Floreat Precinct Structure Plan - Submission

by H. Boogaerdt and N. Ciffolilli

Figure 2. Sunken Howetree Place and Howetree Terrace with footpath and cycleway.

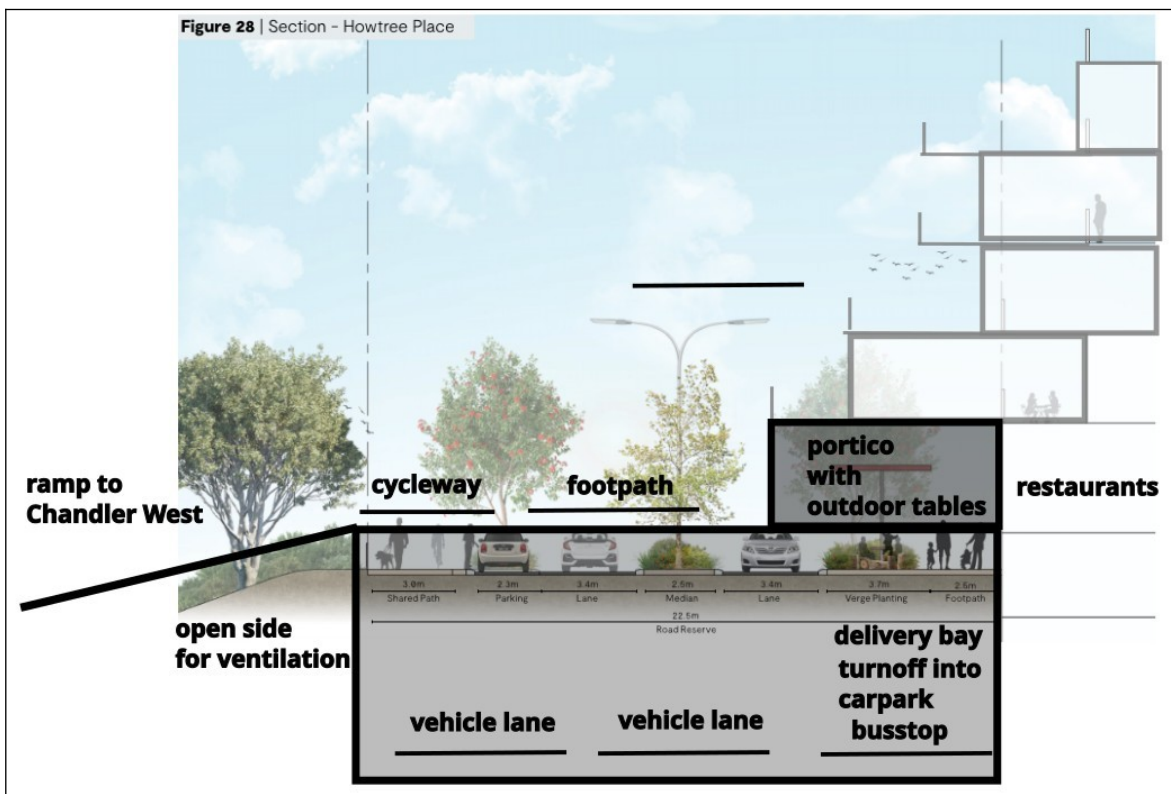
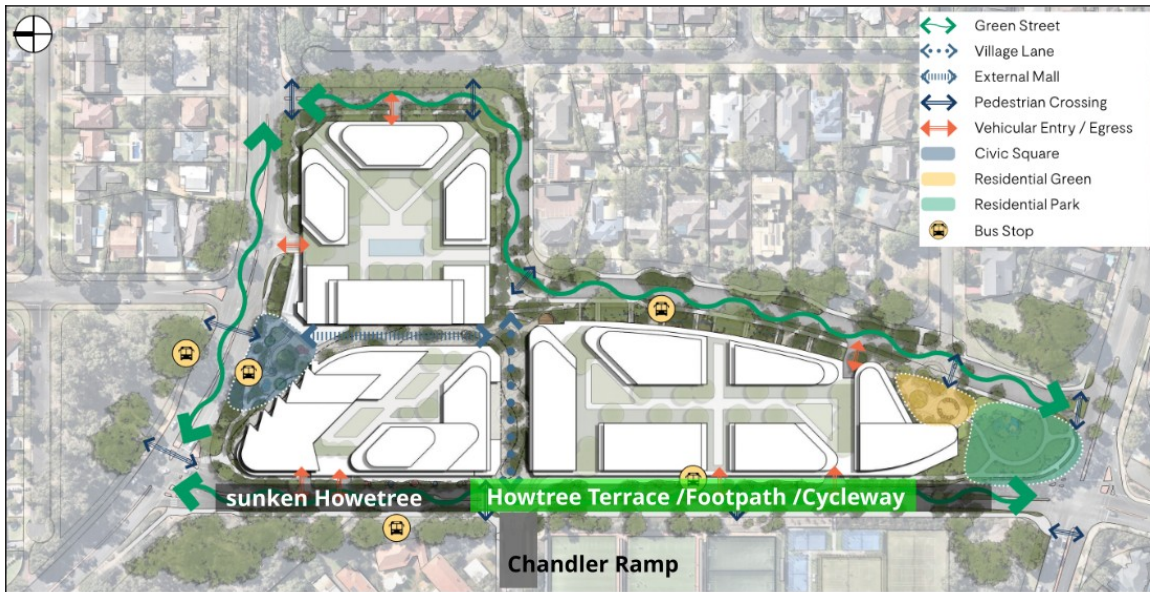
These quotes show the importance of connecting the areas west and east of the Forum to each other via the Forum. Howetree Place is an obstruction to this connectivity, that will be removed if the road is (partially) sunk. Since a large part of the Forum is higher than Howetree and Howetree higher than the sporting fields to the west it should be feasible (Figure 2, 3 & 4). The Howetree Terrace build over the sunken road can contain the north-south cycleway and footpath. If a portico is constructed, they could be an ideal for restaurants to have their outdoor tables. This will have the following benefits:

- Free flow over the Chandler Avenue axis connection of Precinct with Floreat primary School (Chandler West).
- Opportunity for restaurants or conference centre overlooking the sporting precinct.
- Additional public space.
- Place to have the footpath and the cycleway.

- Level access to underground carparks.
- Hiding ugly west facade.
- Will improve the north-south vehicular traffic flow.
- Any passenger waiting at the bus stops underneath would be covered from the elements.
- Increased area over Howetree Place for developers to build.

Figure 7. The FPSP's proposed footpaths.

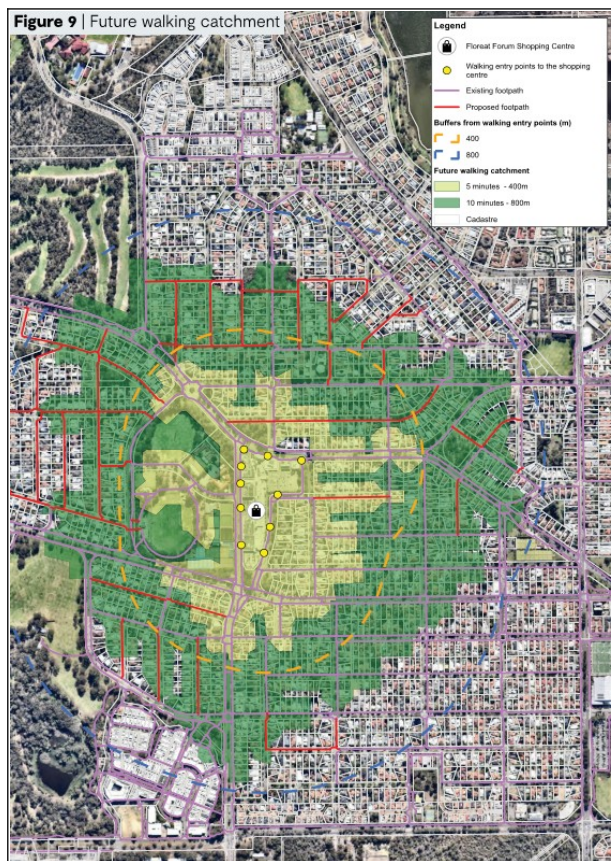
The Town of Cambridge could get more people walking to the Forum independent of the FPSP when it starts constructing the proposed footpaths (and cycleways) as indicated in Figure 7. With sustainability as an aim the use of poured concrete footpaths needs to be rethought. The slab size (600 x 600) used in WA maybe too large but for example in the Netherlands they use 250 x 250 size slabs which seems to work well to get even paths.

In the report on page 54 figure 8 on the west side reports 5 entry point only 2 entry points that includes the carpark entry should be used, the other 3 are incorrect.

Figure 8. Road layout of figure 28 and 29 in favour of vehicular traffic.

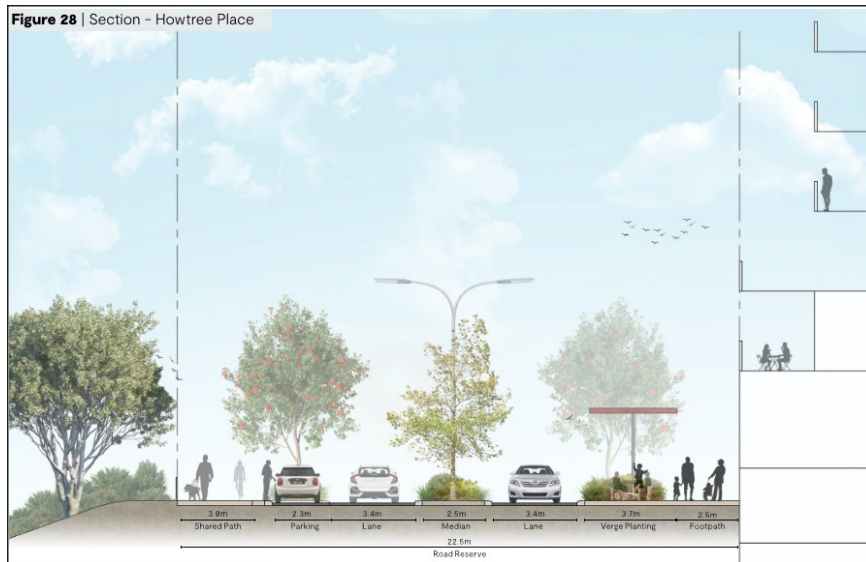
Report figures 28 and 29 shows no separated cycleways and trees in median strip (figure 8). Remove this median strip and use that space to create a separated cycleway. Shared paths, with the advent of electric scooters and bikes, have become

unsafe for the pedestrian (Guardian, 2024). It is important to move away from painted line delineation for a cycle way. In Belgium they call these just by painted line separated bike paths "Death Strips", that description is self-explanatory. The underlying thinking in both figures still vehicle oriented.
